ADDENDUM No. 01

Shalimar Elementary School Cafeteria Renovation

September 24, 2026

ARCHITECT – Heffernan Holland Morgan Architecture

Drawing No:
SH-A1

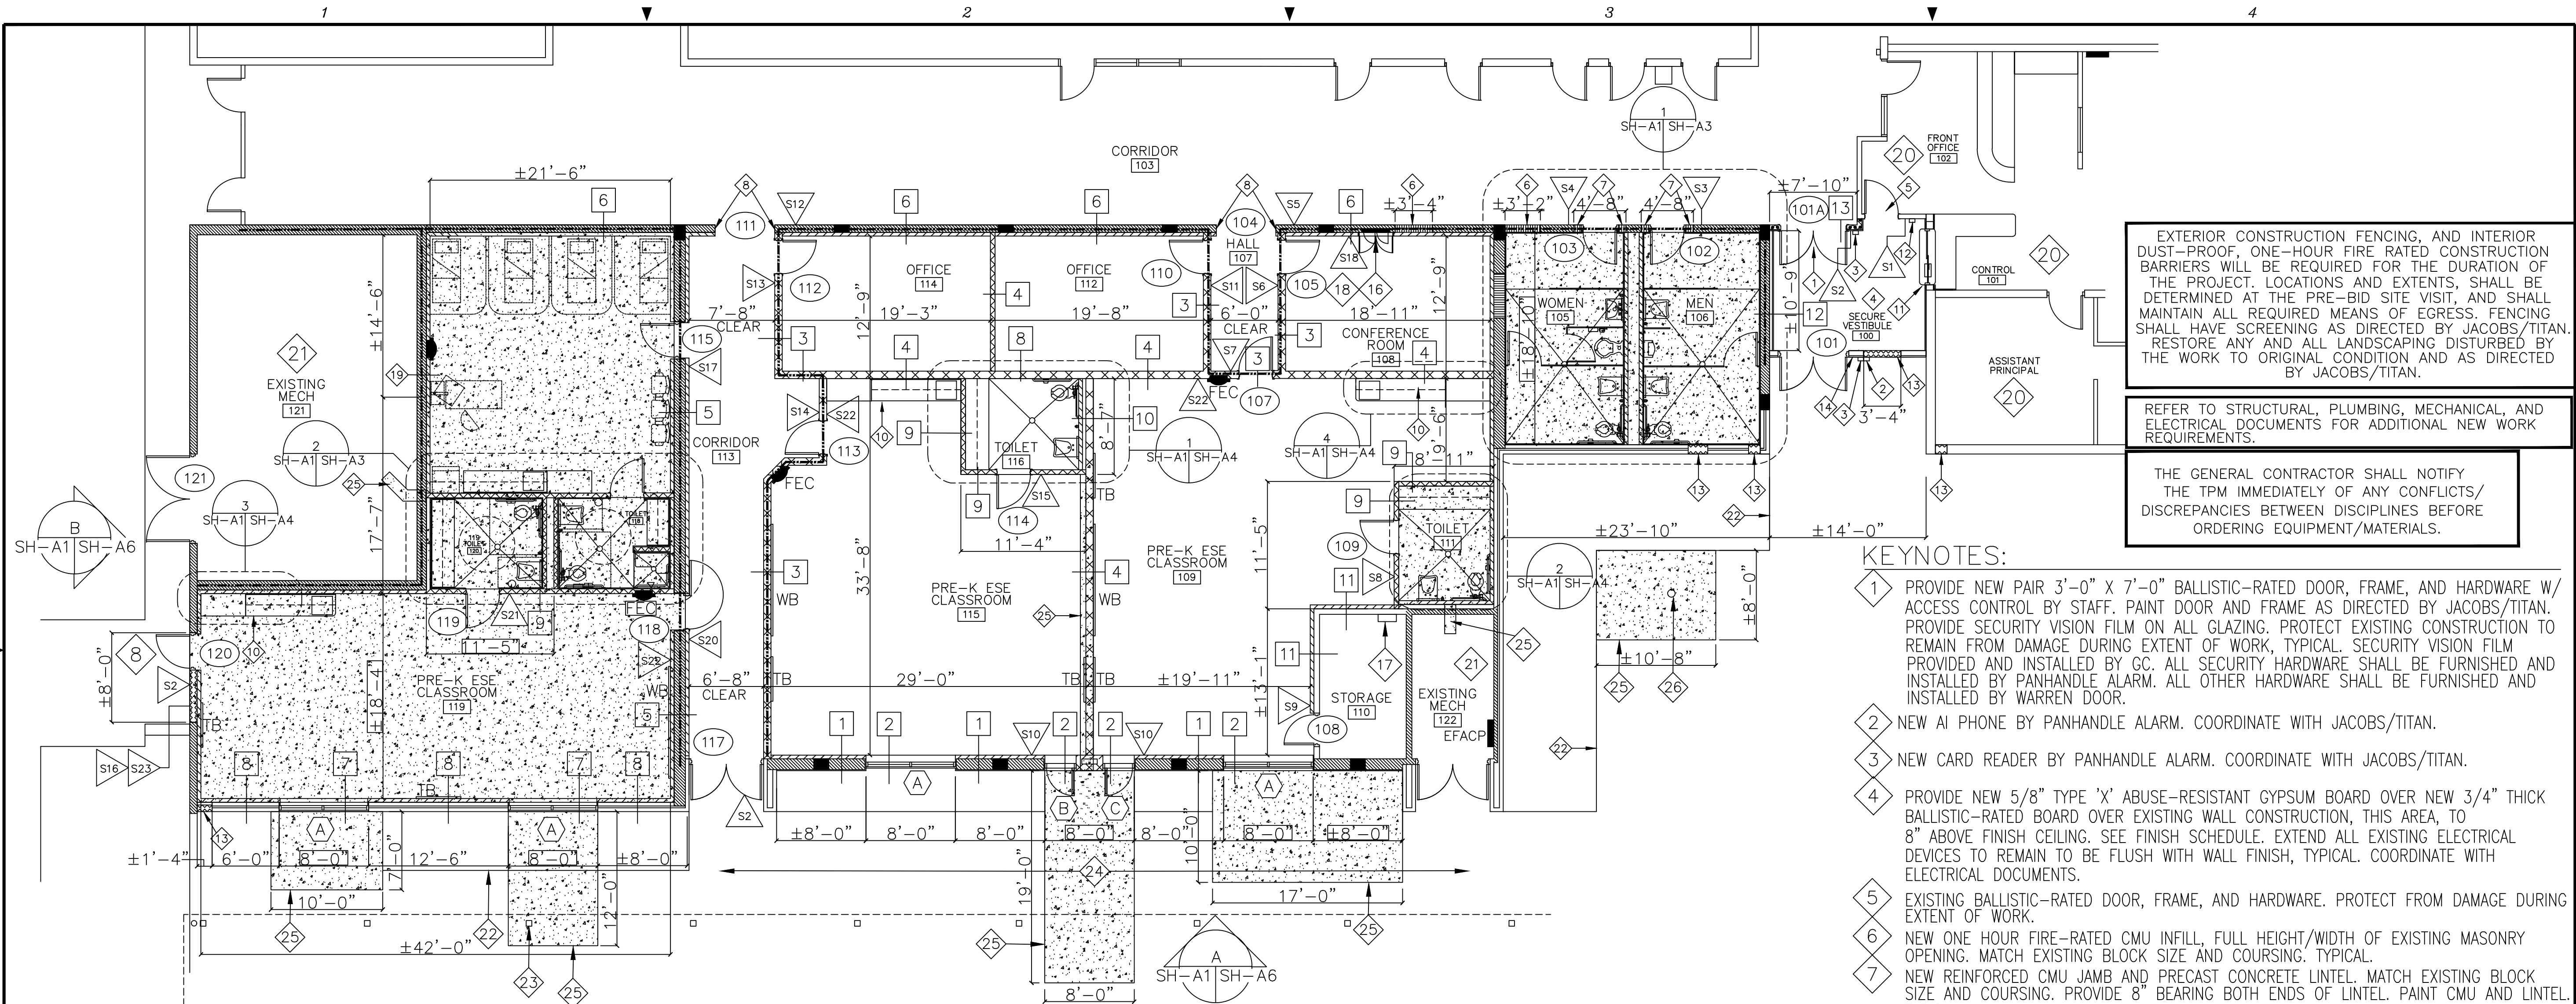
2. **REF:** SH-A1/ Keynote 26
Question: Please provide spec for the new flag pole.
Answer: See attached LIBERTY FLAGPOLES ECA40 SPECIFICATION. GC will need to provide concrete for surrounding area as noted on Attachment G.

Answer: No projection screen or projectors will be needed for this project.
4. **REF:** SH-A1
Question: Reference Section 10100 – Visual Display Boards. Provide location and sizes of Marker / Tack Boards.

Answer: See and reference new attached SH-A1 for locations and sizes of marker / tack boards.

Designed By: JEF Drawing No:
Drawn By: JEF
Checked By: PDM SH-A7

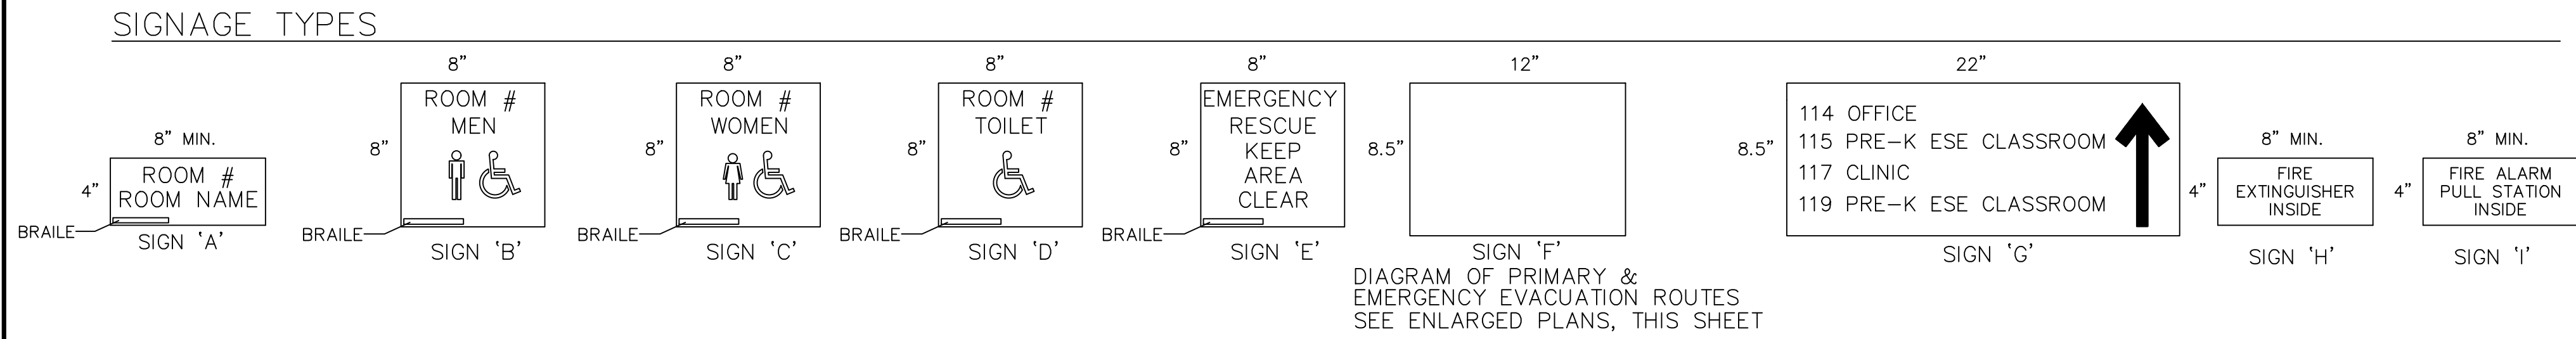
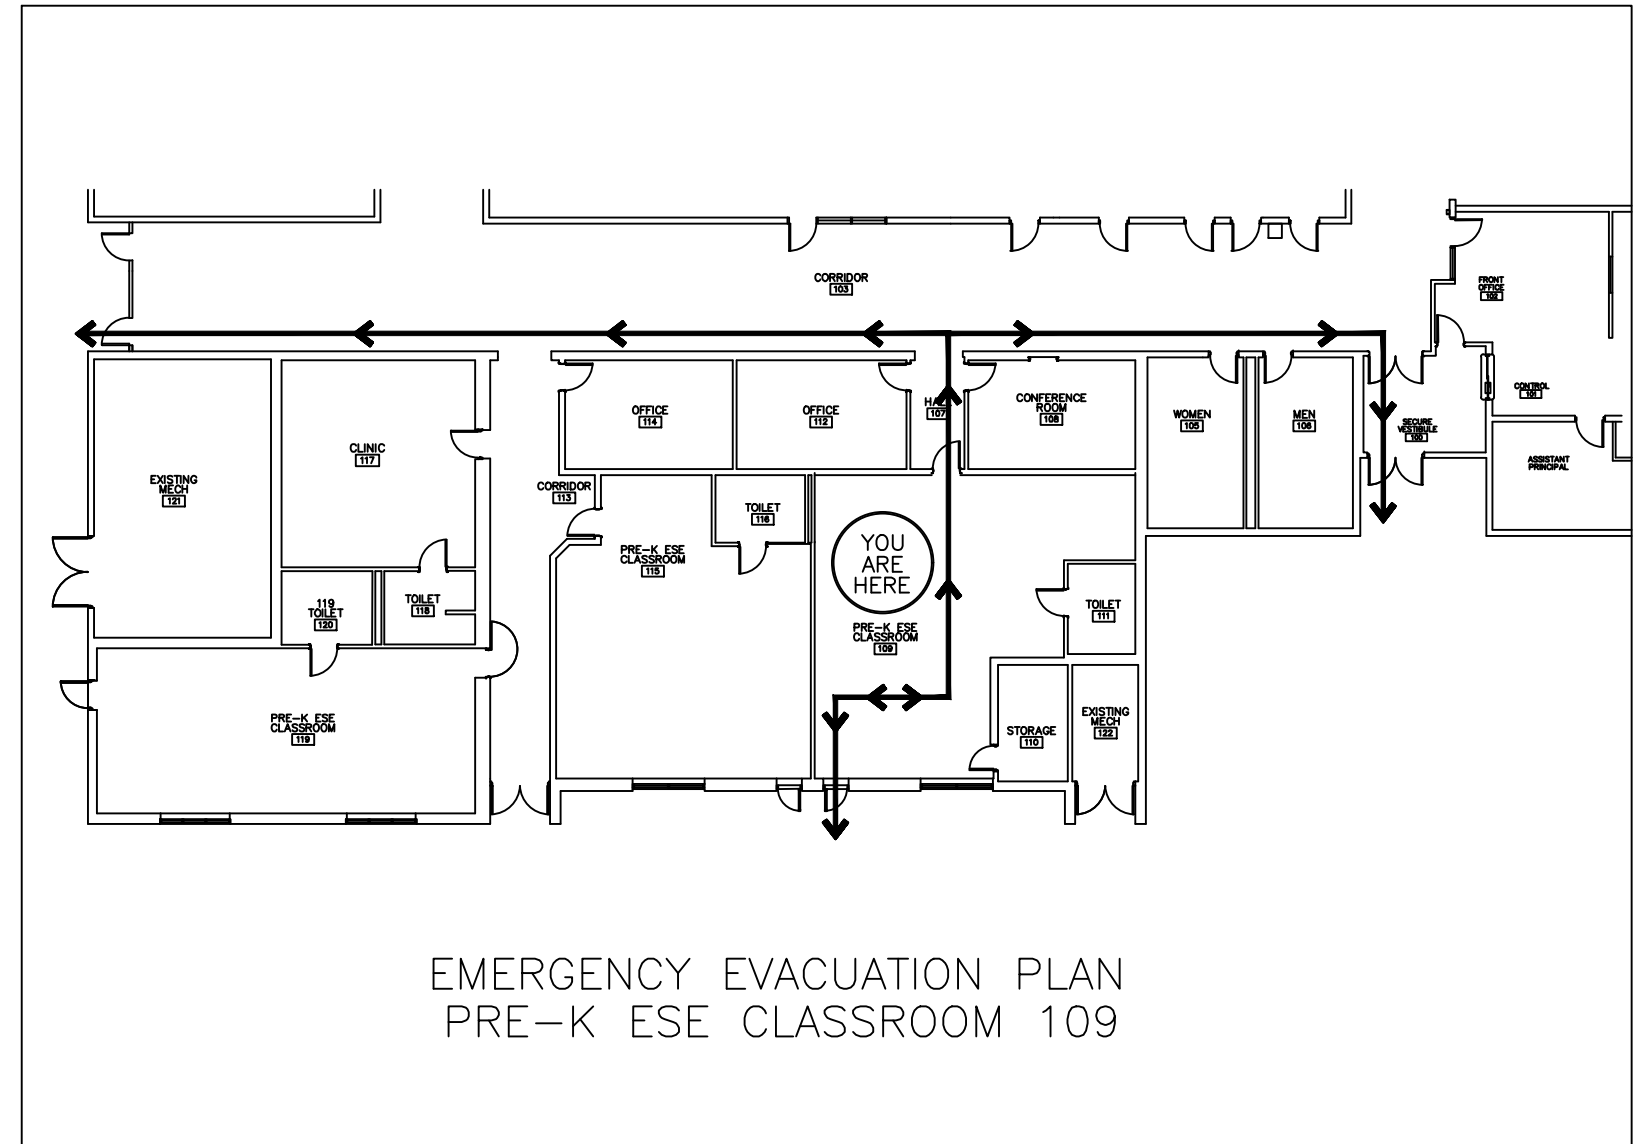
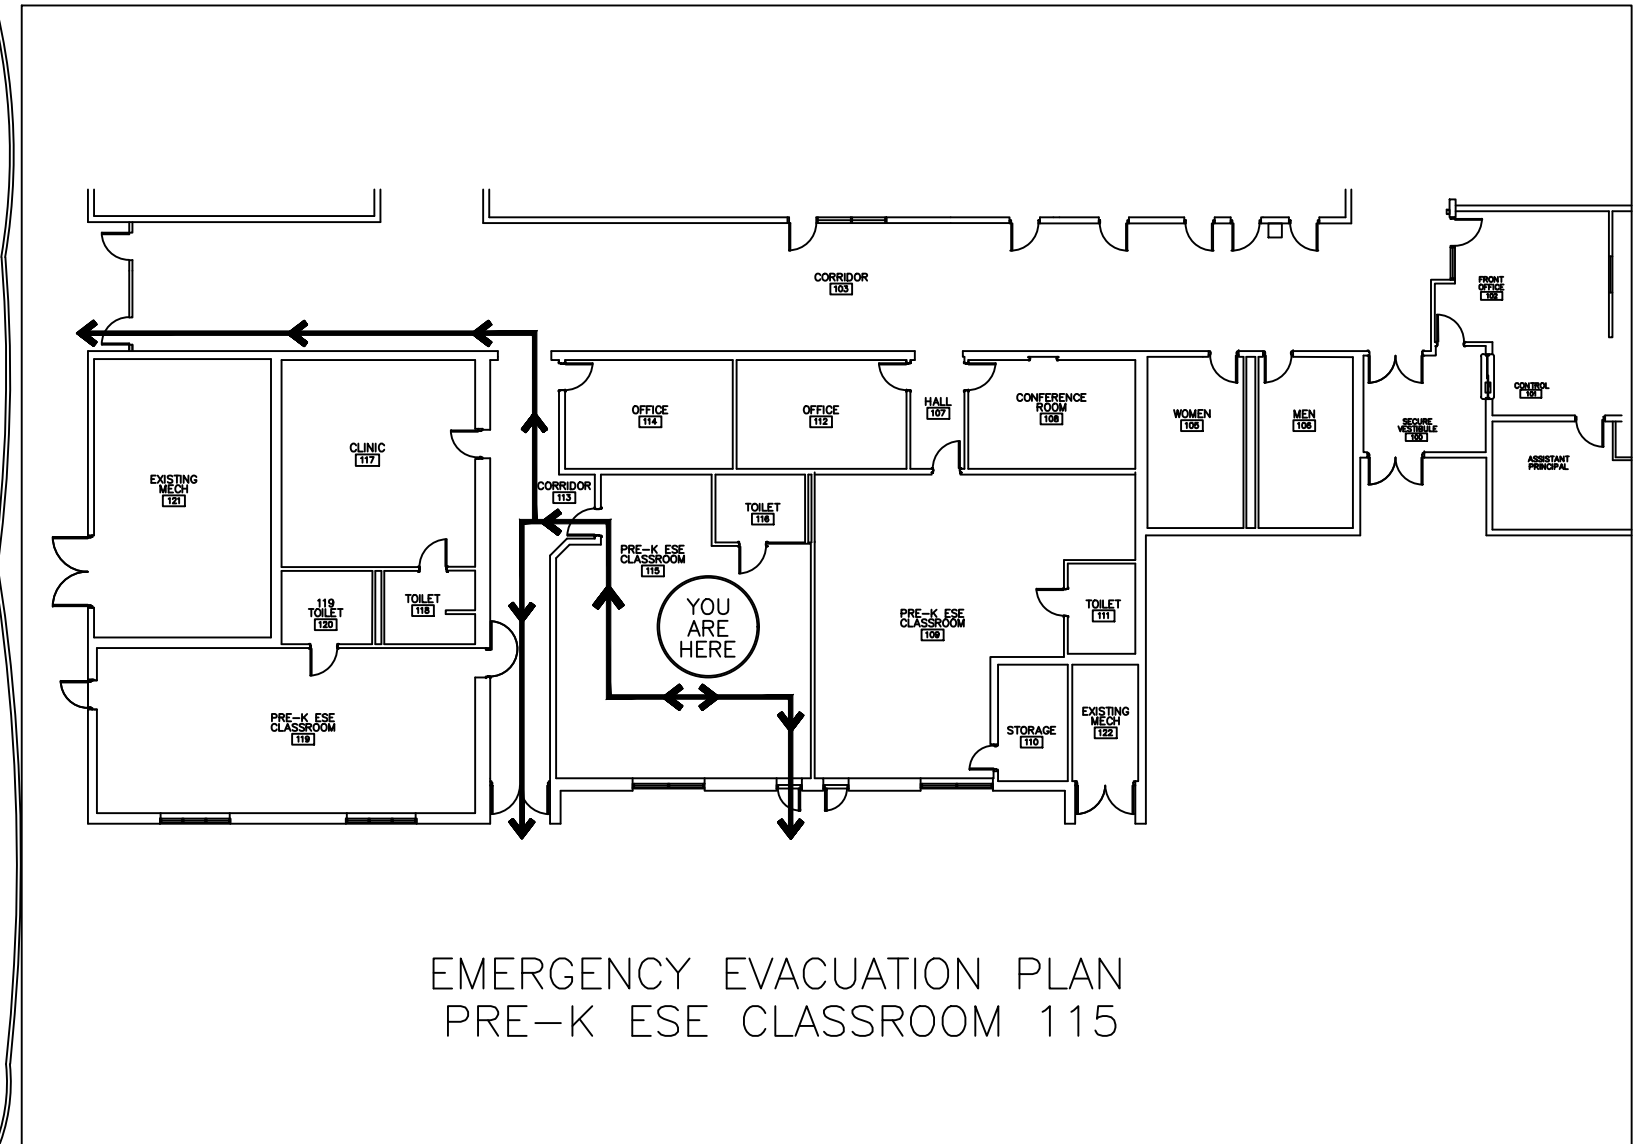
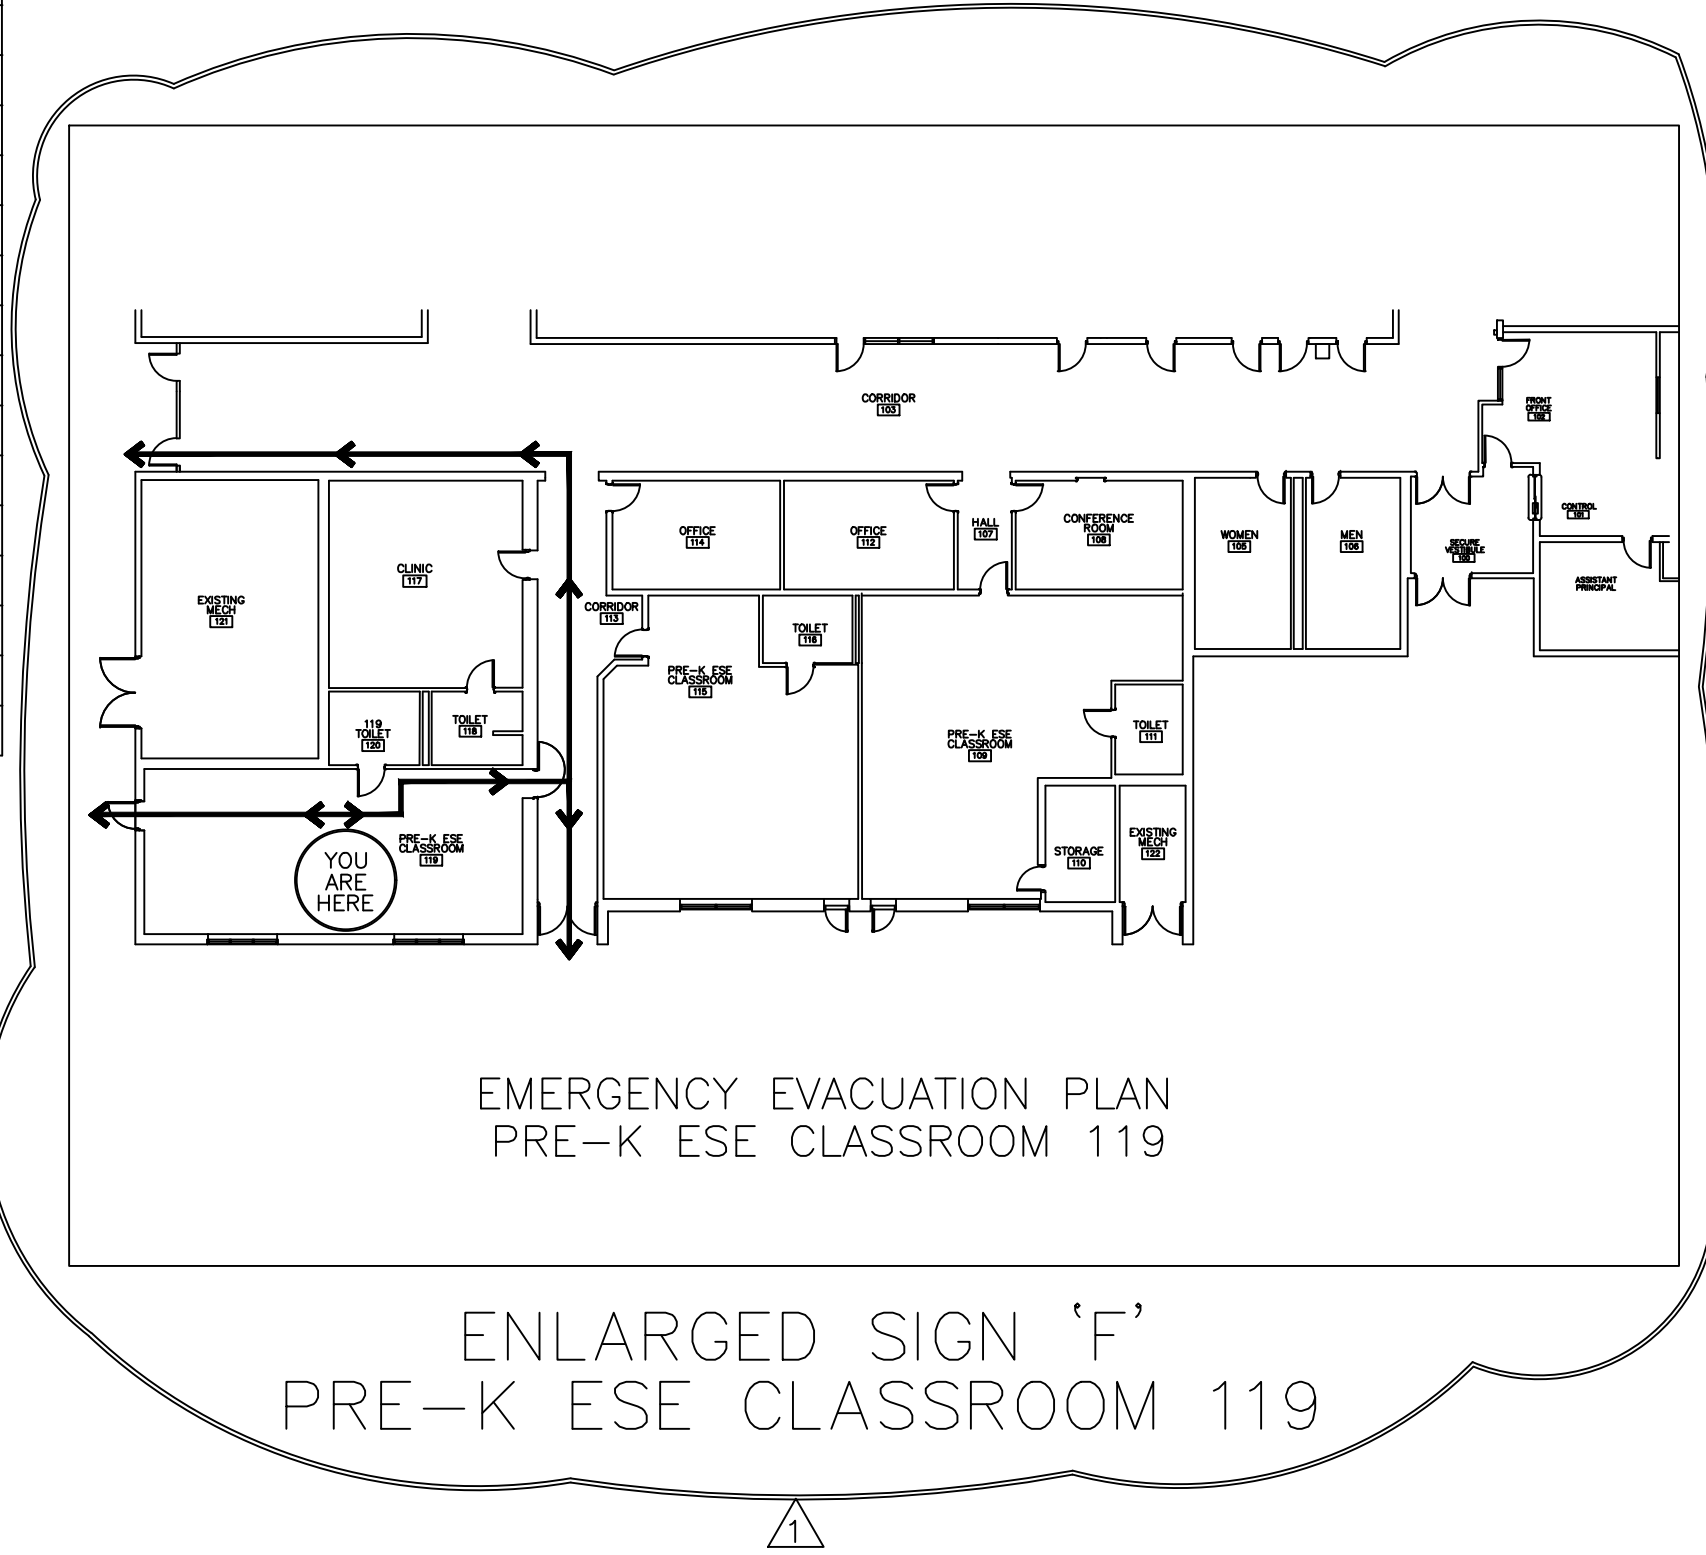
Answer: Reference SECTION 09660 – RESILIENT TILE FLOORING and ATTACHMENT E – SHALIMAR ELEMENTARY SCHOOL FINISHES SCHEDULE.
6. **REF:** SH-A7
Question: Reference Sheet SH-A7 signage schedule. Provide requirements for Mark S26 – Exterior Signage

Date: 9-23-26 By: JEF Description: CLARIFY ENLARGED EGRESS SIGN FOR ROOM 119

Answer: Sign Type A, Verbiage " Front Lobby", Letter size 1", quantity: 1
7. **REF:** SH-A8
Question: Sheet SH-A8 Door Schedule - Door Type "C" that requires a door lite are in (20 min) rated doors. Glazing for these doors is indicated as G2 which is tempered glass. Will the temper glass meet the 20 min rating?
